## Poplar Pointe, Preliminary Plan No. 120180080

Staff Report Date: 11-19-2018

### Description

Request to subdivide four unplatted parcels into twelve single-family detached lots and retain one existing dwelling on one of the twelve lots; including open space and HOA parcels.

Figure 3: 2012 Pre-Preliminary Plan Proposal

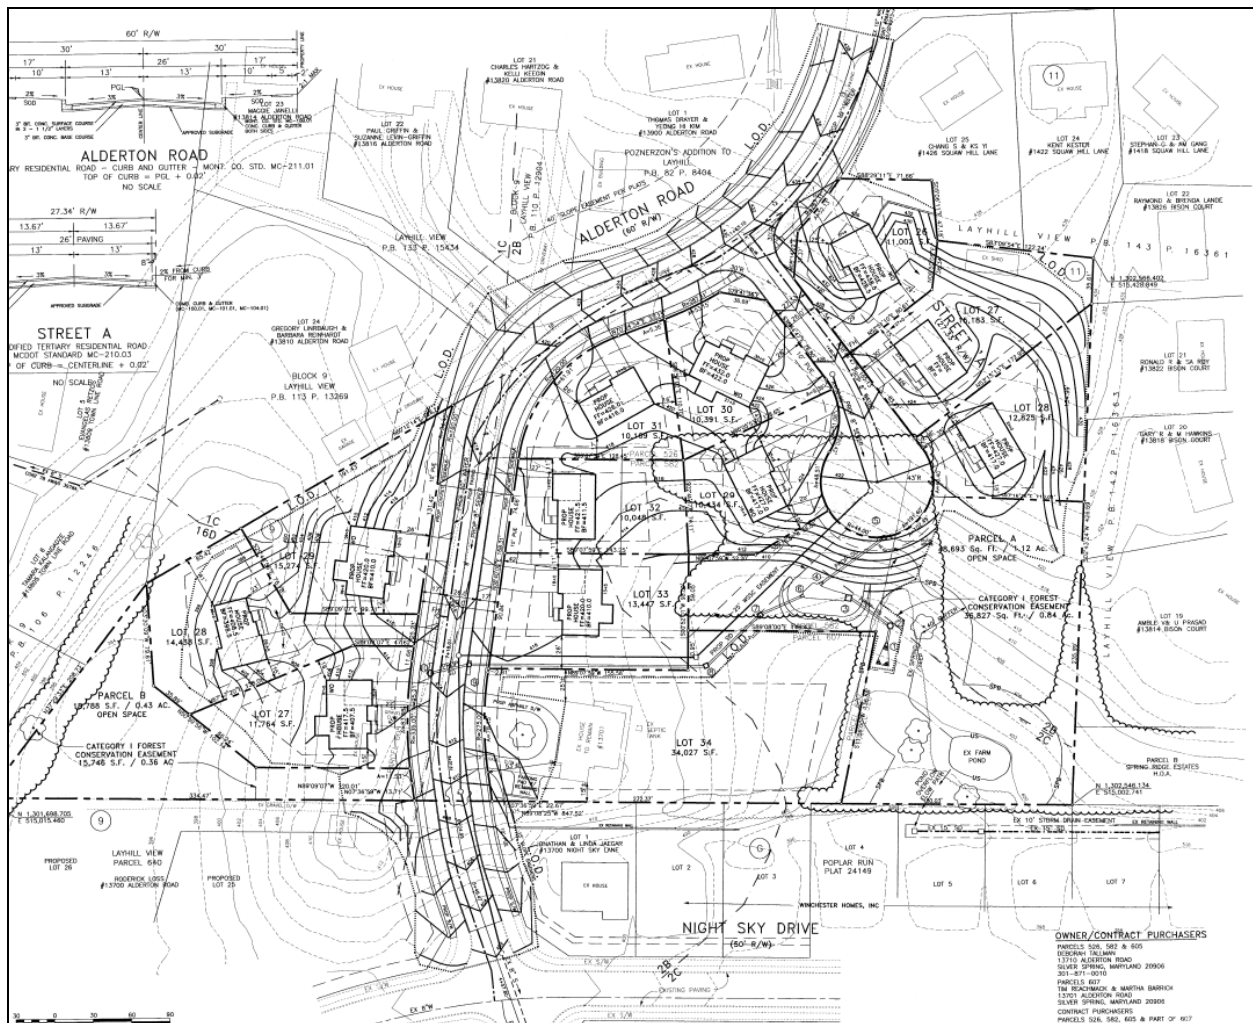
Staff supports the current proposal, because it addresses Staff's concerns from the 2012 Pre-Preliminary Plan. The new layout uses shared driveways rather than pipe stems and cul-de-sacs to access eight of the twelve houses, and the location lots and units have been situated in a way that preserves a larger amount of Common Open Space and Conservation Easement area, which yields a much more efficient open space network justifying the clustering of the lots.

Figure 5: Location of 13648 Alderton Road (Lot 26)

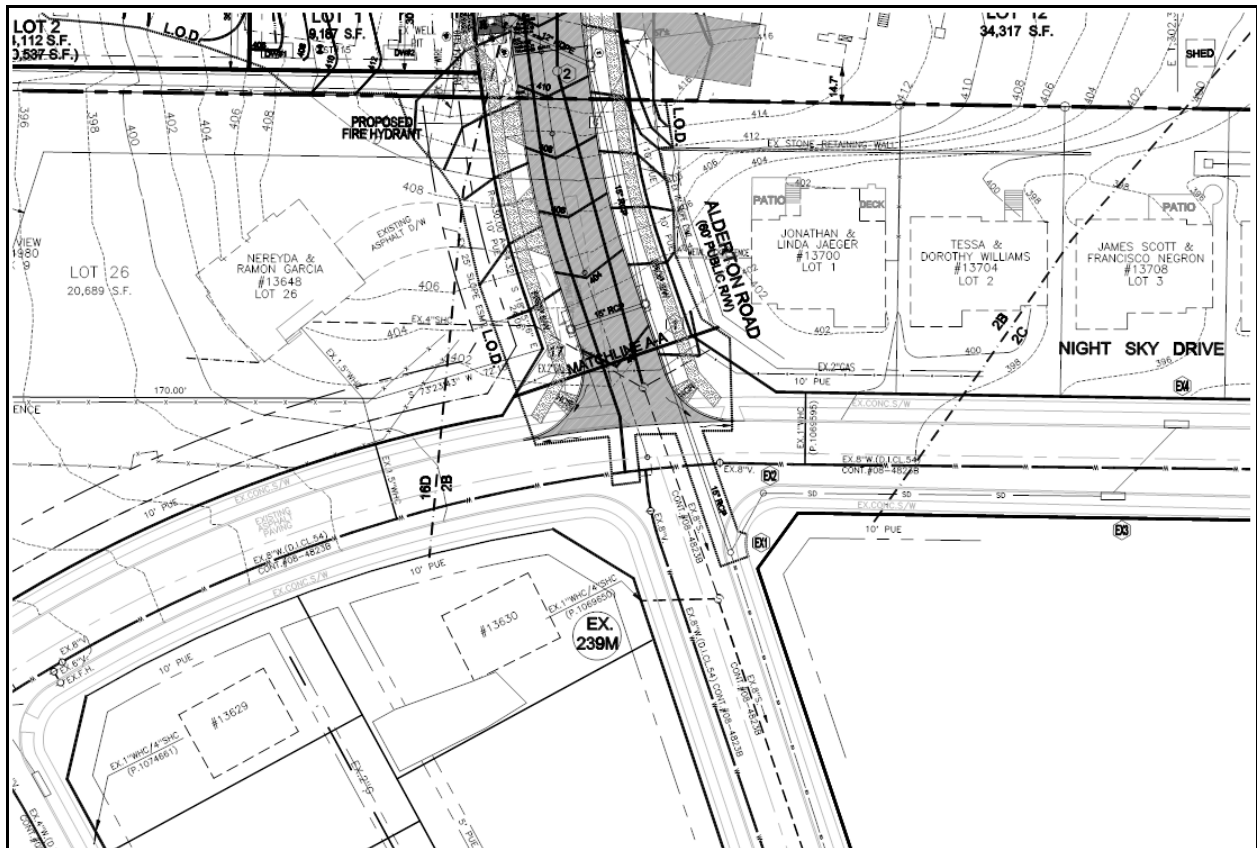
- The size of the proposed easement is too large and too close to the rear of their property;

- Construction activities will generate dust and dirt and may cause structural damage to their property; and
- Decrease in the value of their property.

The Applicant met with the resident, who wrote the letter raising the concerns summarized above, to discuss their concerns. After that meeting, the Applicant agreed to modify the design to minimize disturbance to the resident's property. The Applicant will meet with the resident once the construction drawings are complete to discuss the project schedule and impacts. The MCDPS will ensure all residential construction requirements are met to minimize and prevent dust, dirt and structural damage due to construction activities.

Figure 7: Constraints and Impacts

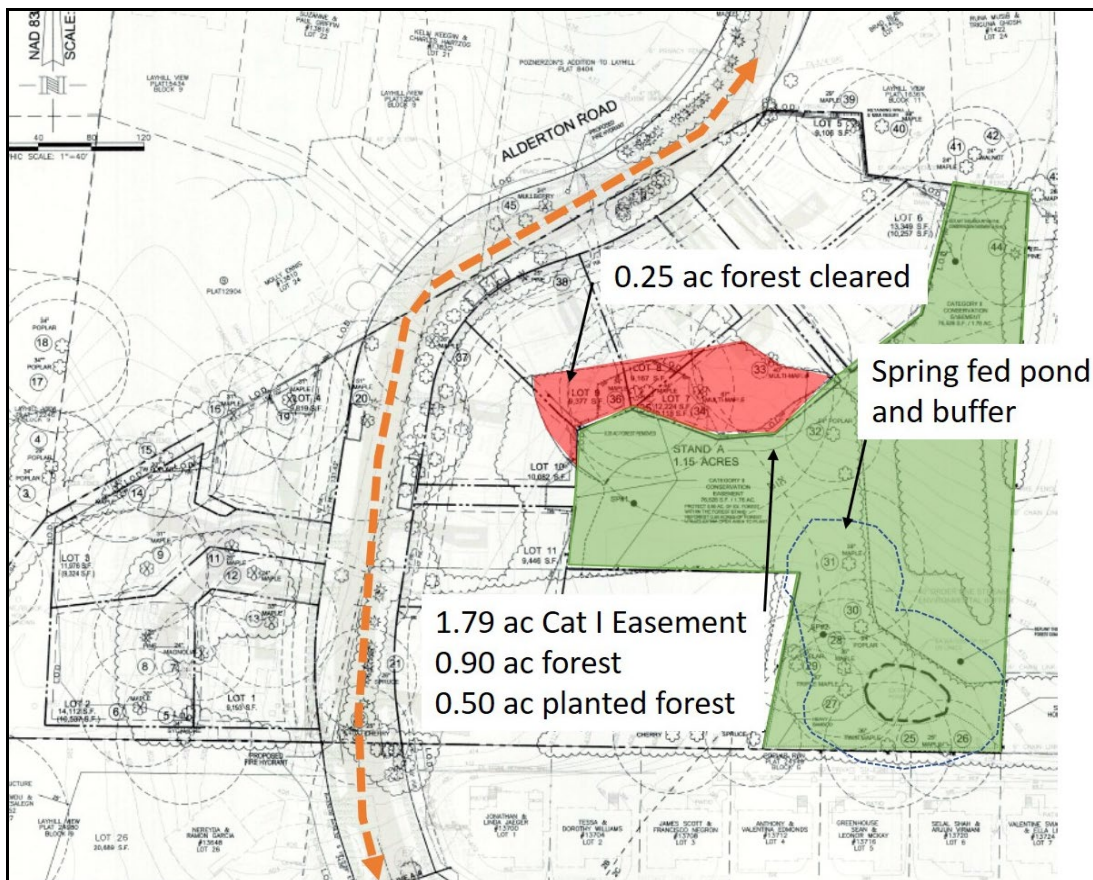
The Property is subject to the minimum retention provision because R-200 is a single-family zone and the Applicant is proposing to use the cluster development optional method of development. The conservation threshold for this property is 20%, or 1.40 acres. The Applicant is retaining 0.90 acres, 0.50 acres below the requirement.

Given the constraints associated with developing the Property, the Applicant is clearing 0.25 acres of forest but planting 0.50 acres of forest. Staff recommends that the Planning Board find that, when all of the site constraints are considered, it is not possible for the Applicant to develop the property without clearing 0.25 acres of forest.

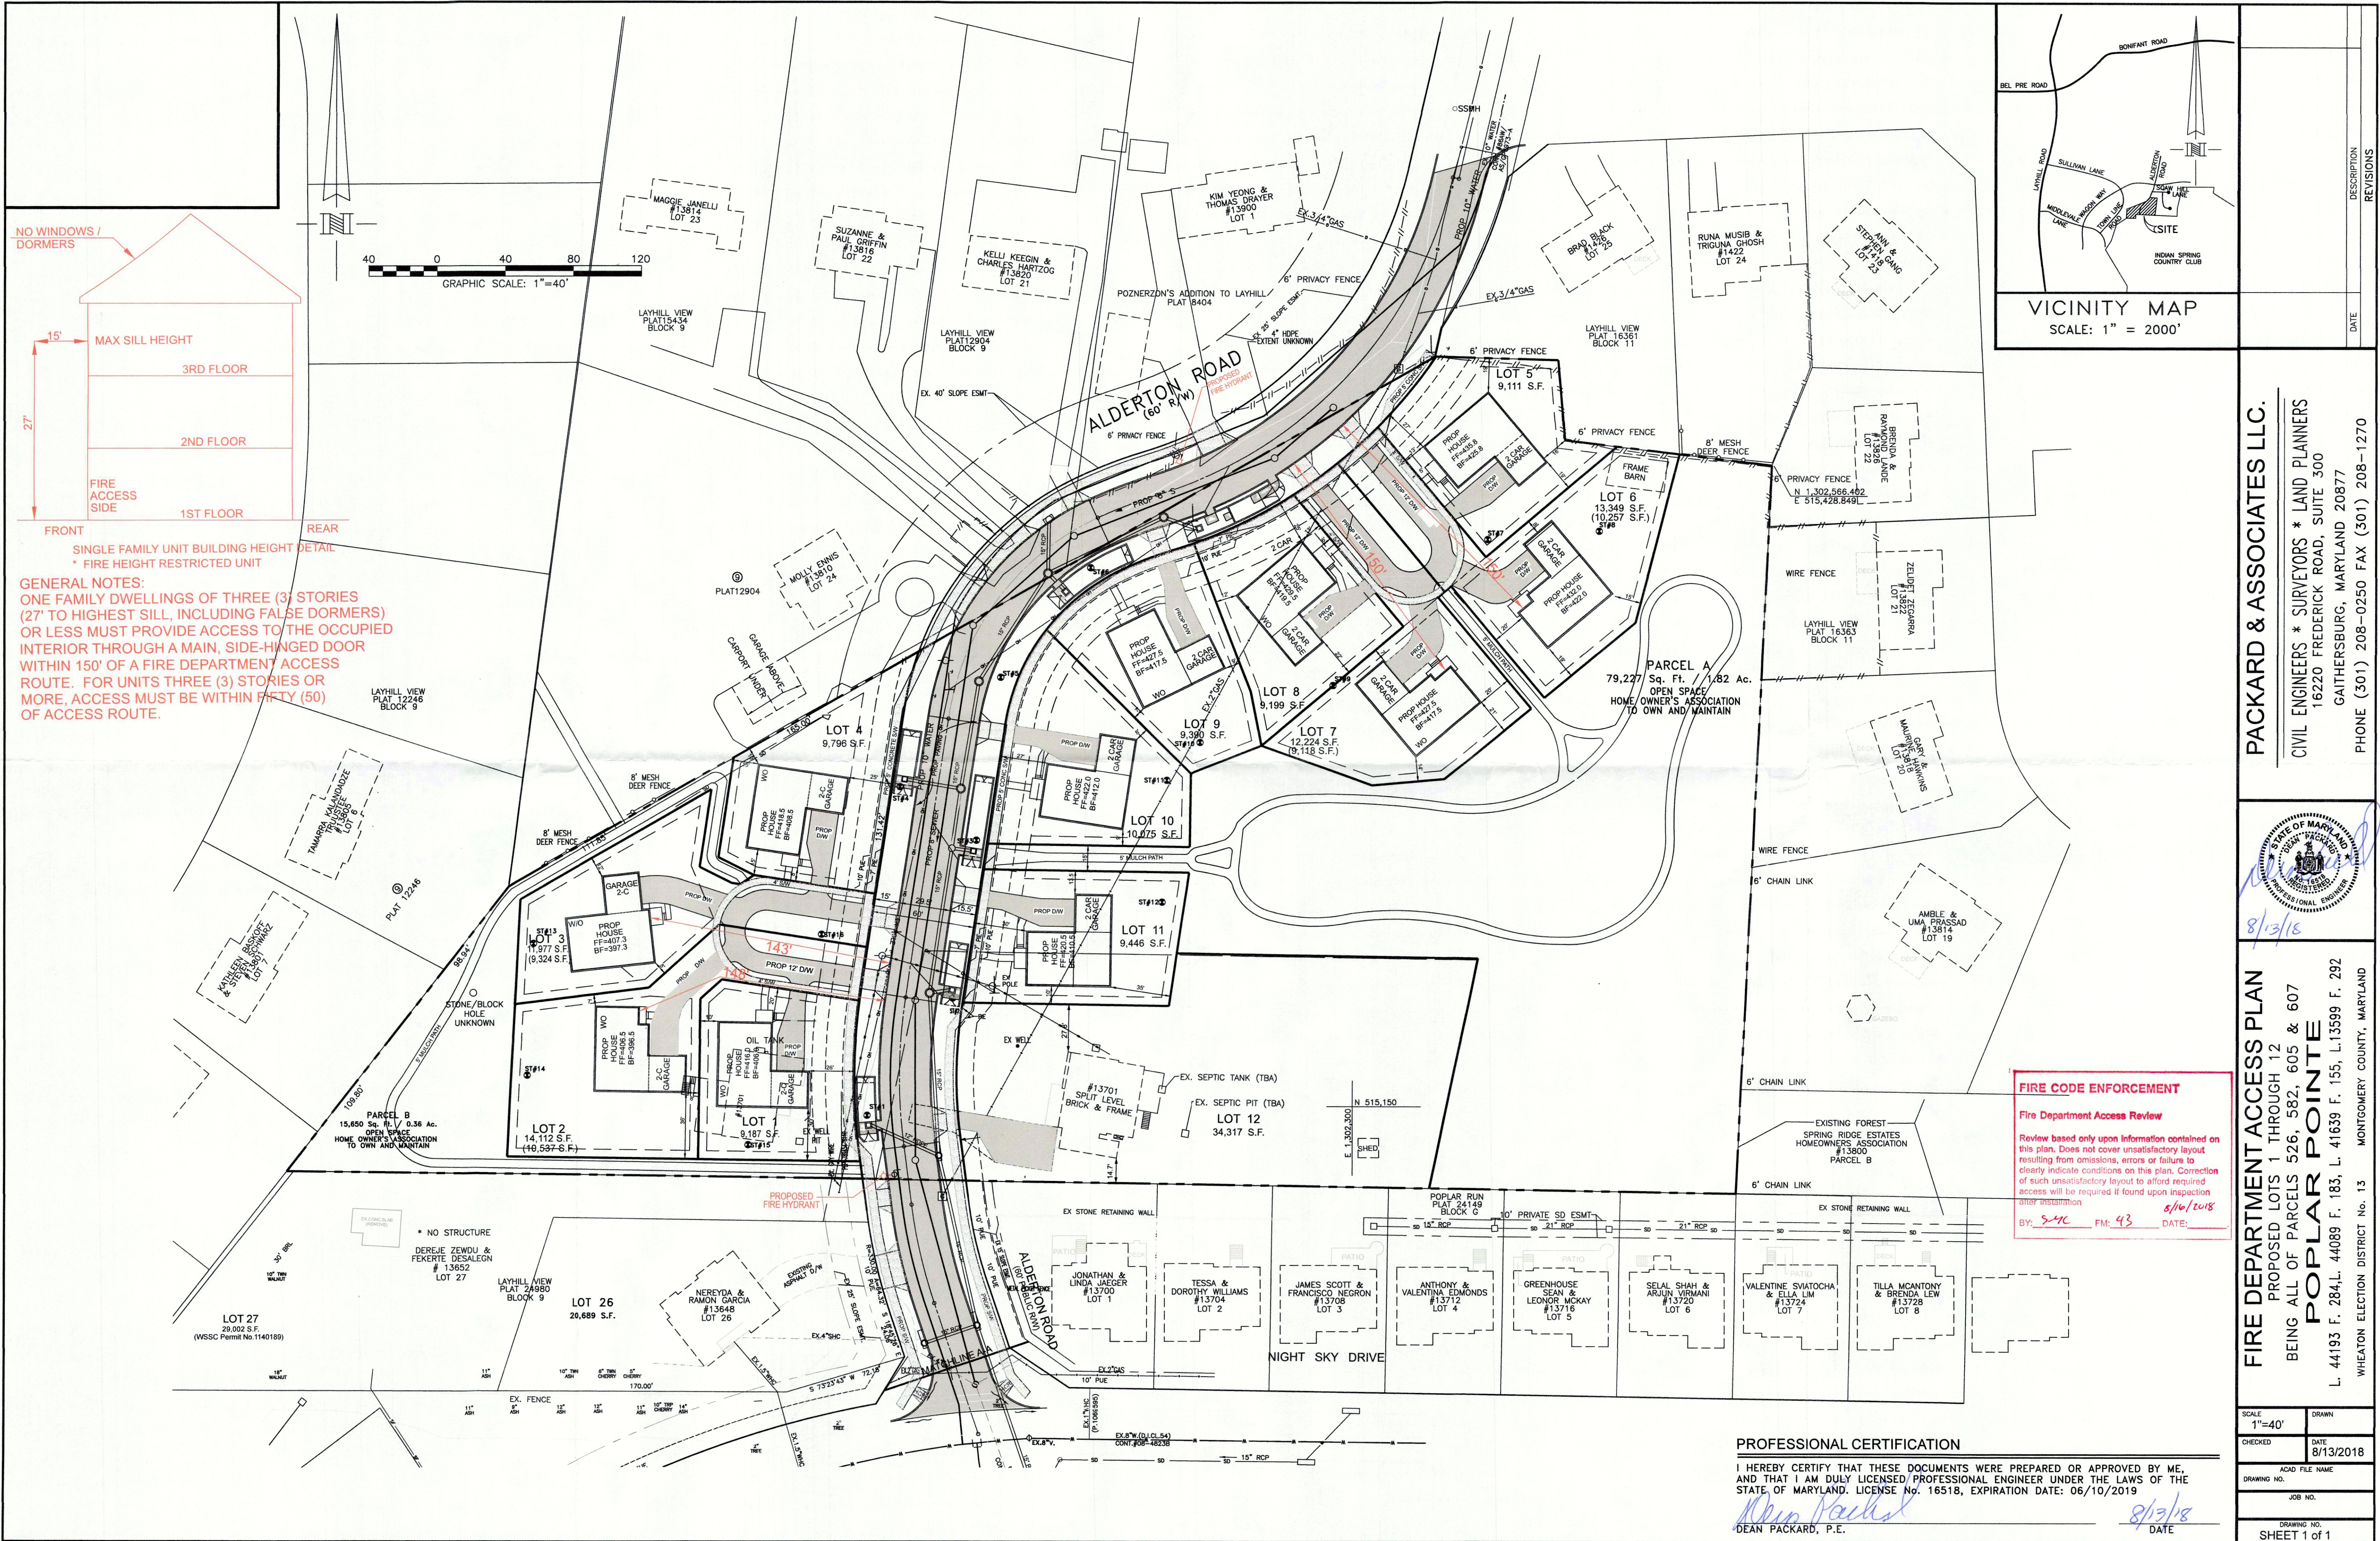
GENERAL NOTES:  
ONE FAMILY DWELLINGS OF THREE (3) STORIES (27' TO HIGHEST SILL, INCLUDING FALSE DORMERS) OR LESS MUST PROVIDE ACCESS TO THE OCCUPIED INTERIOR THROUGH A MAIN, SIDE-HINGED DOOR WITHIN 150' OF A FIRE DEPARTMENT ACCESS ROUTE. FOR UNITS THREE (3) STORIES OR MORE, ACCESS MUST BE WITHIN FIFTY (50) OF ACCESS ROUTE.
